PLAN OF PROPOSED SUBDIVISION

OLD BULLI HOSPITAL

LANDSCAPE MASTERPLAN

LOT 1 DP326181, LOT 1 DP83742, LOT 1 DP595930,
LOT 1 to 8 DP7677 & LOT 19 to 22 DP6793
LANDCOM - OLD BULLI HOSPITAL
27-29 HOSPITAL ROAD, BULLI
PROPOSED SUBDIVISION - DA CIVIL DRAWINGS

2.3 Trees

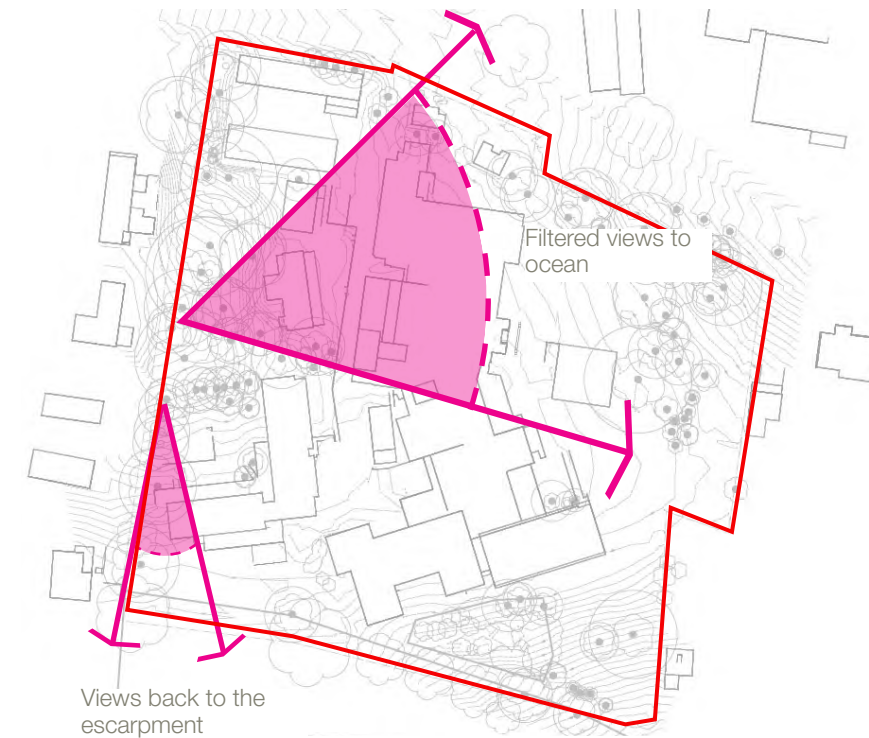
22.10.2024 – Analysis plan 2.3 updated to include additional trees retained in response to Wollongong City Council's RFI dated 2 August 2024

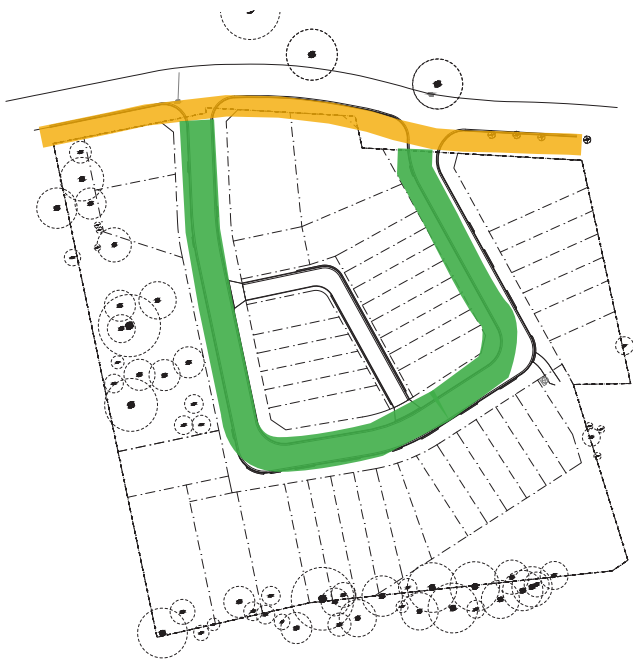
04.04.2025 – Plan updated to include a updated design to the Hill Top Park in response to Wollongong City Council's comments.

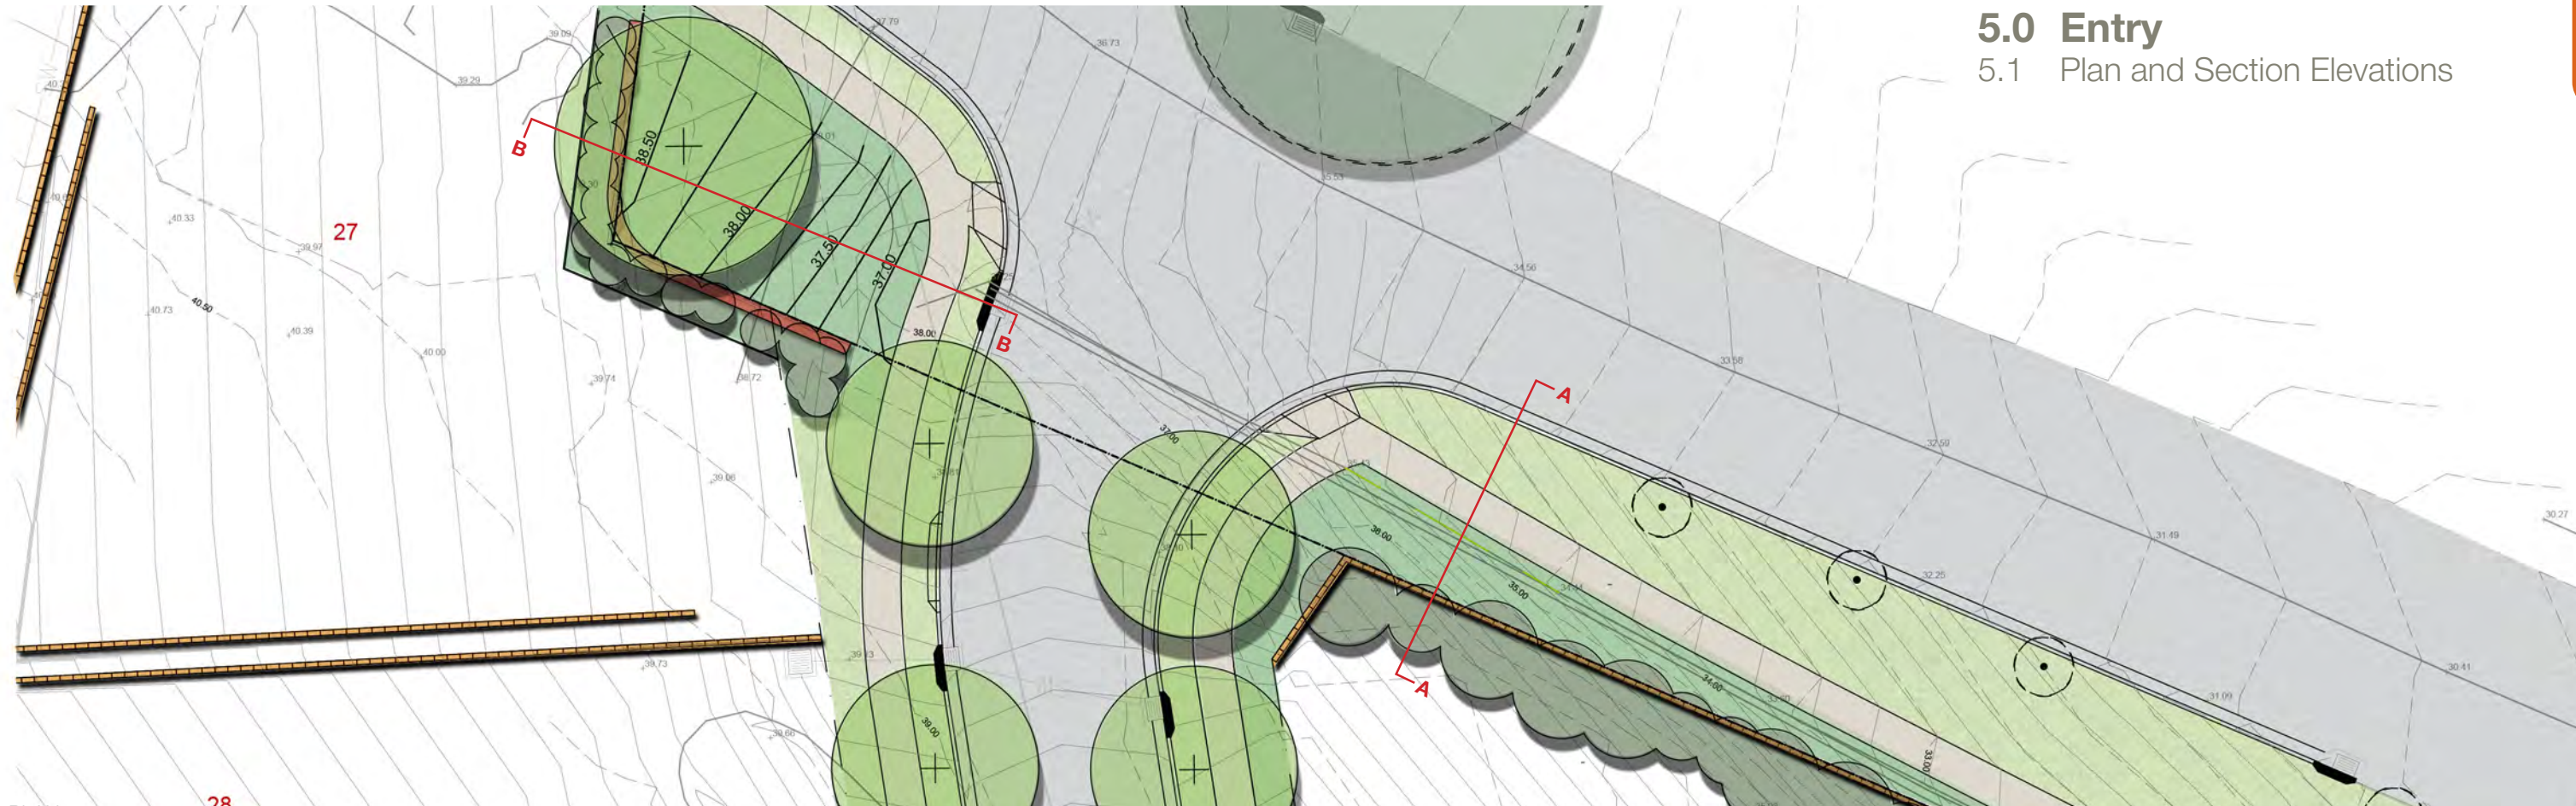
04.04.2025 Plan updated to remove elements from Hilltop Park between retaining walls and replace with turf as requested by Council

5.0 Entry
5.1 Plan and Section Elevations

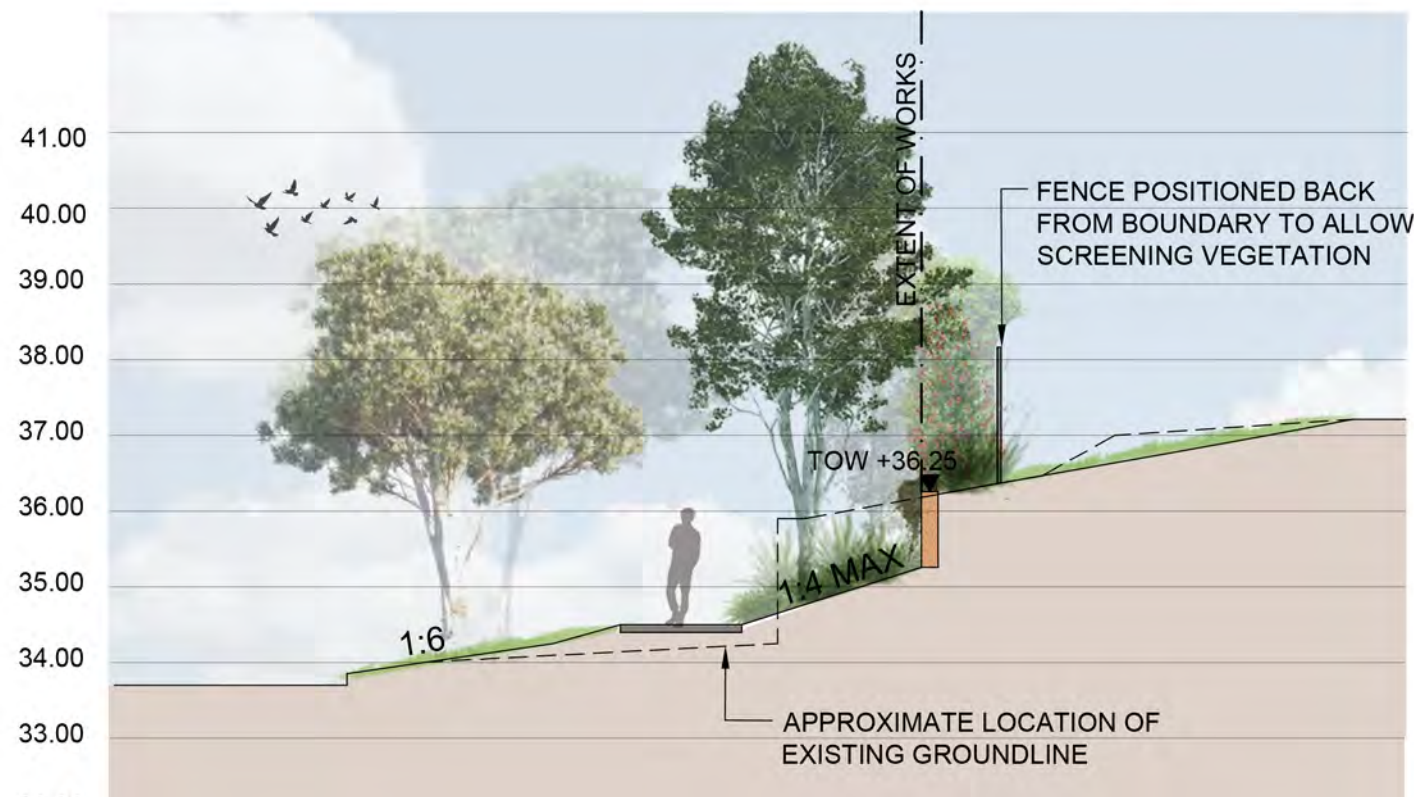
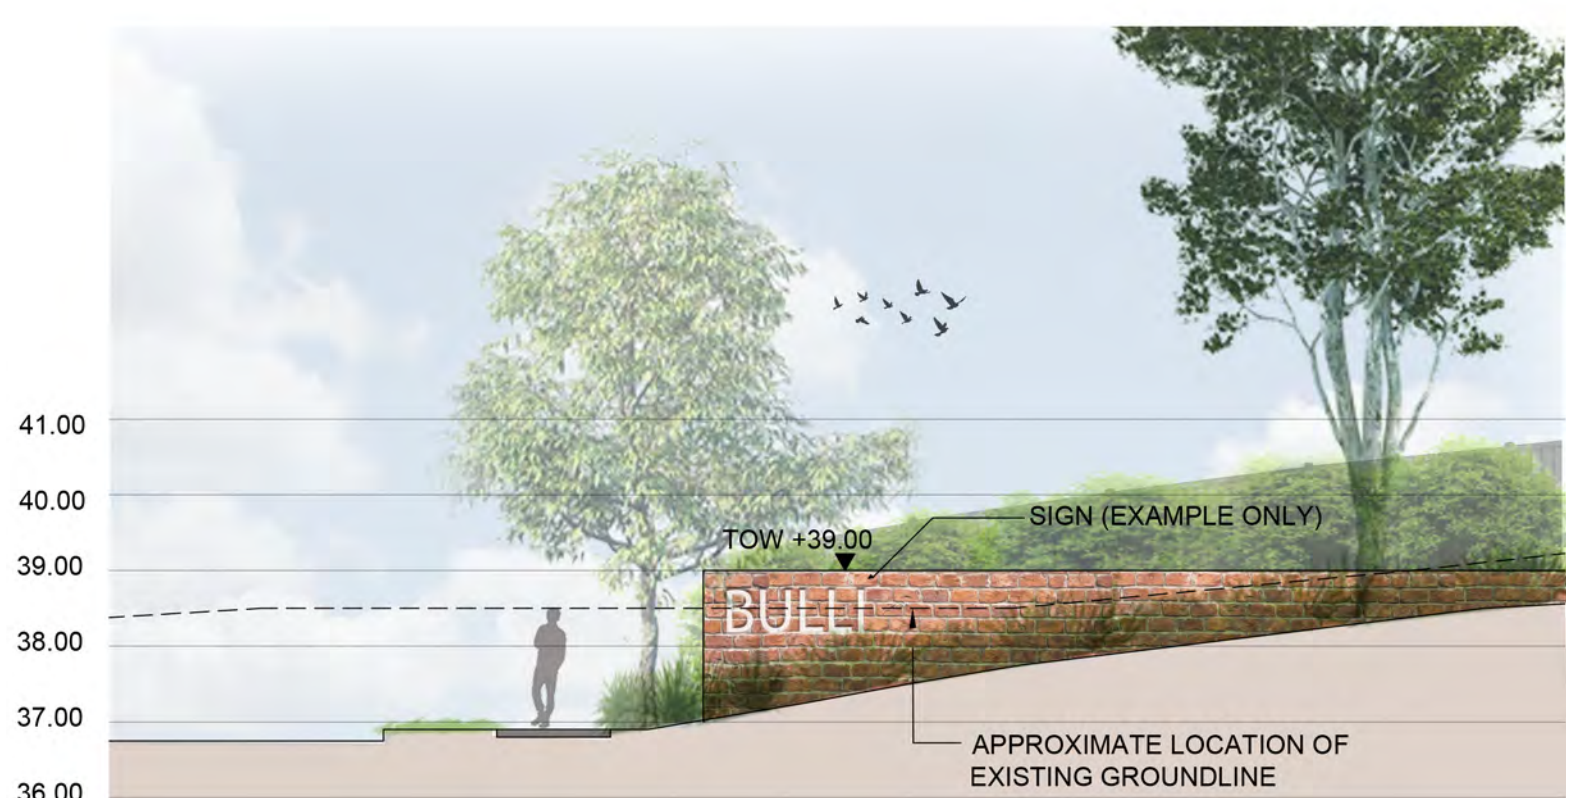
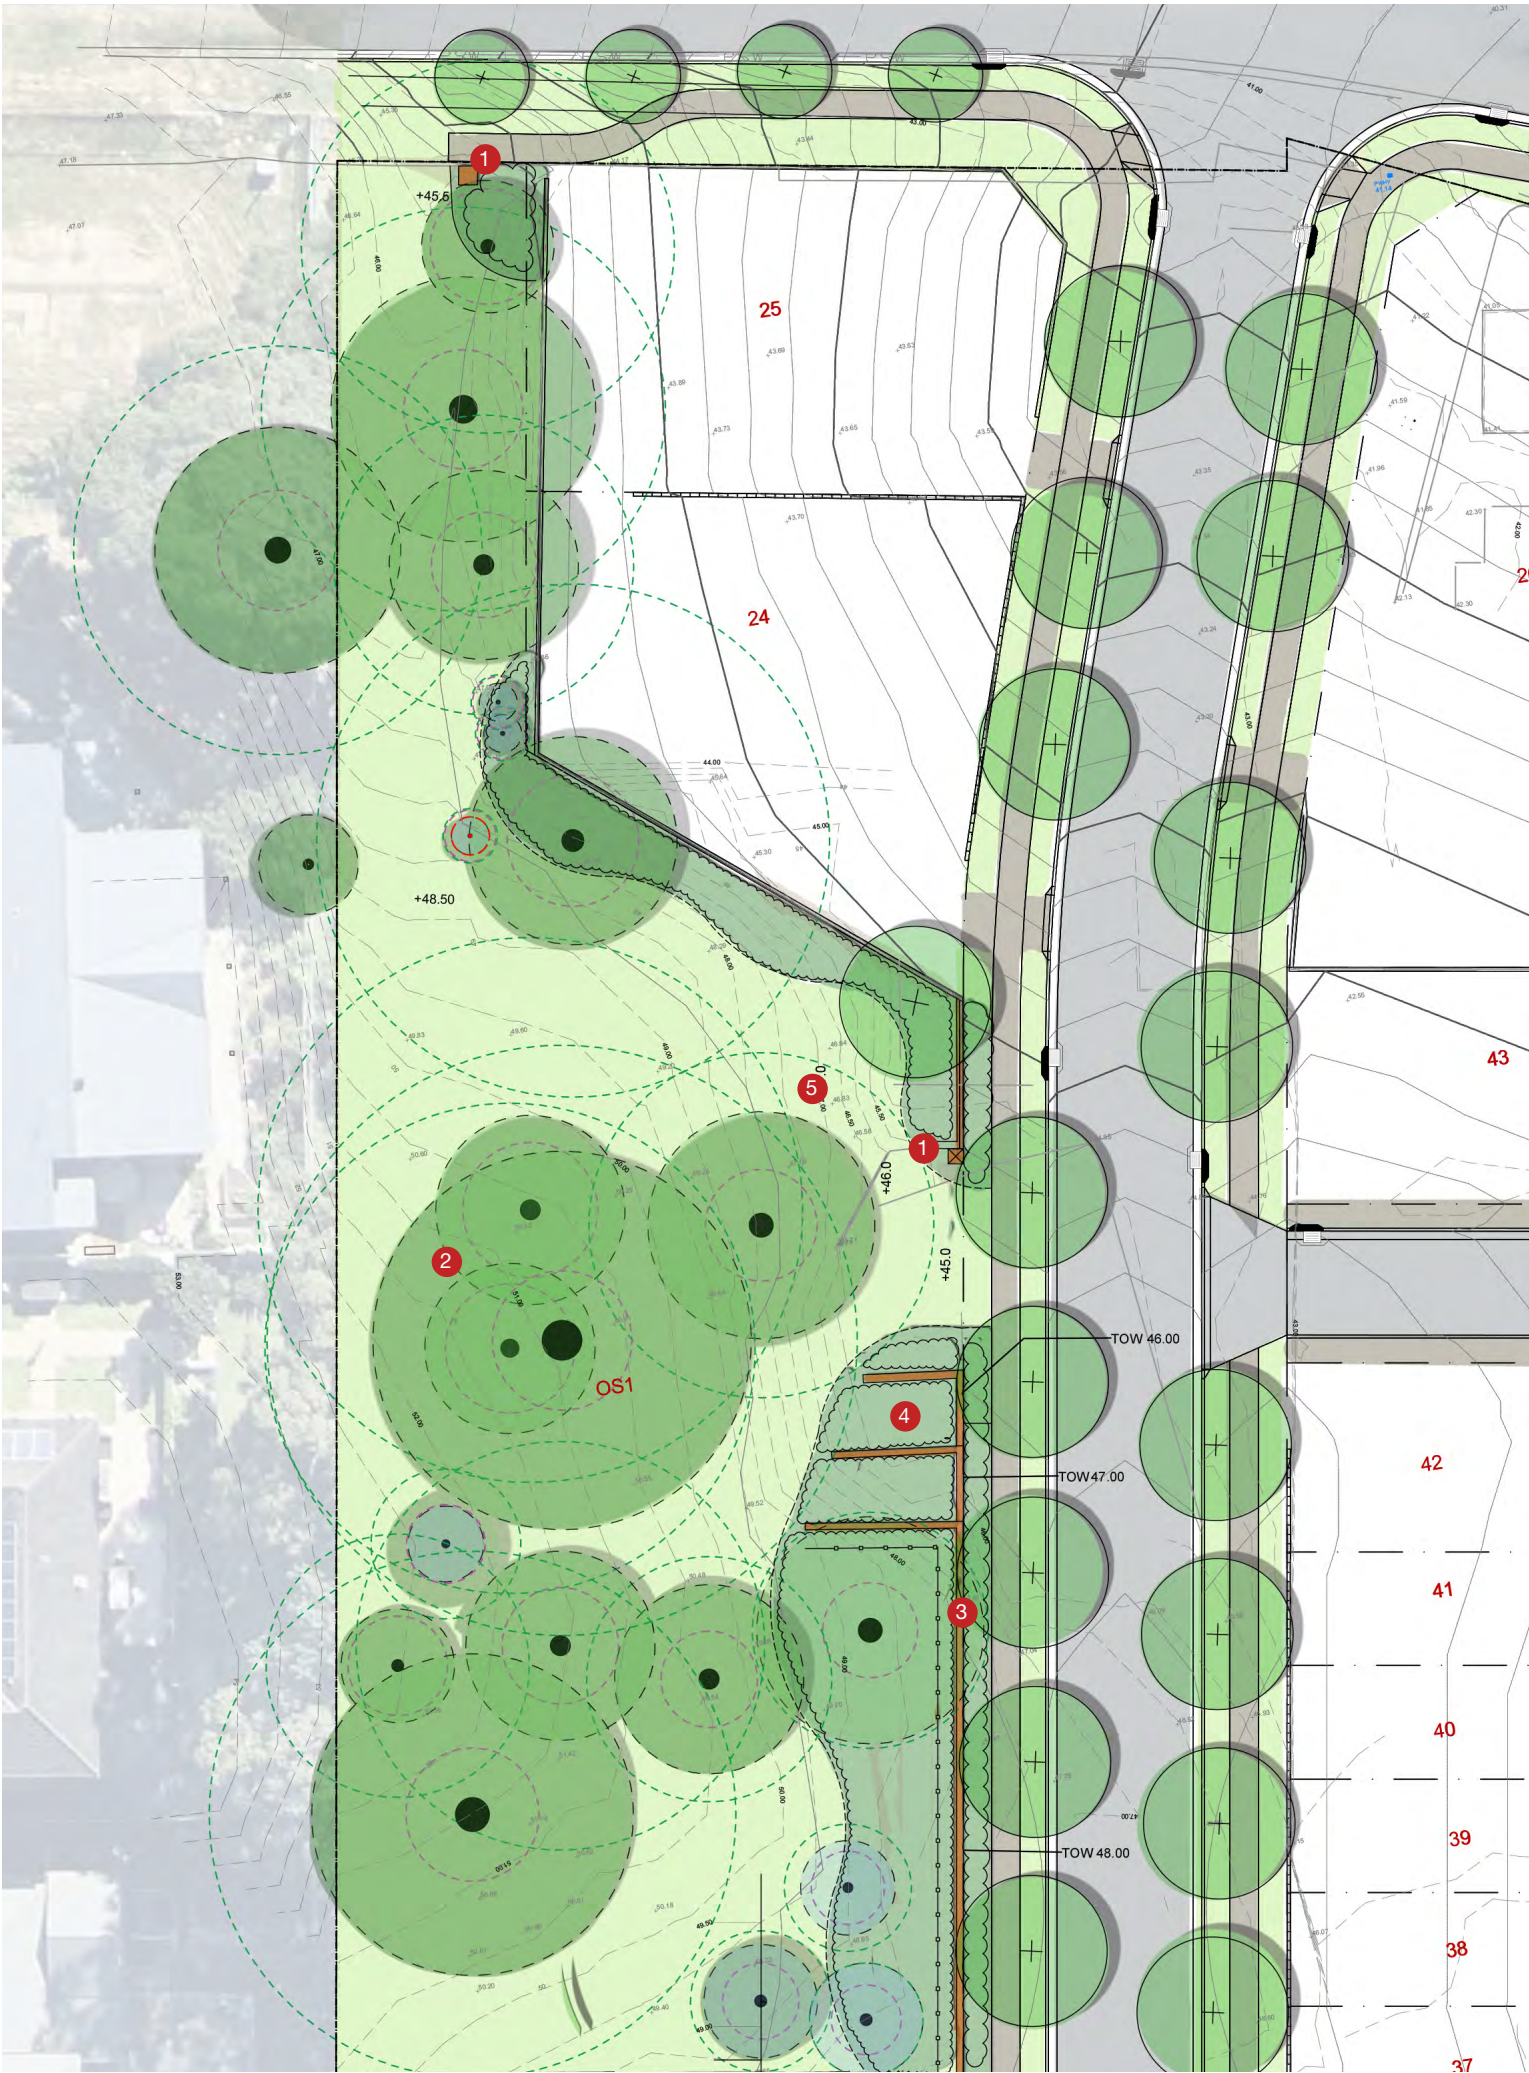
LIST OF CHANGES
22.10.2024 – Plan and section elevations update to reflect the new design to the front entry of the site.
